# Technical Service Bulletin

## 20 Fuel cannot be added to vehicle or fueling vehicle is difficult

20 16 68 2044039/1 April 28, 2016.

Model(s)	Year	VIN Range	Vehicle-Specific Equipment
Q7	2017	All	Not Applicable

*Figure 1. Broken flap inside of filler neck.*

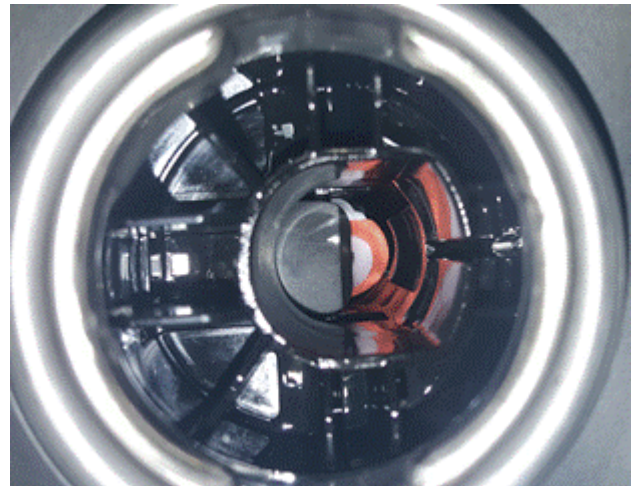
Vehicle does not accept fuel, is slow to refuel, or it is difficult to insert the fuel pump nozzle.

There is a broken flap inside of the filler neck (Figure 1).

Improved flap design of the filler neck.

Replace complete fuel tank according to the instructions in ELSA at: *Repair Manual*>>*Power Unit*>>*Fuel Supply*>>*Fuel tank*>>*Removing and installing fuel tank*.
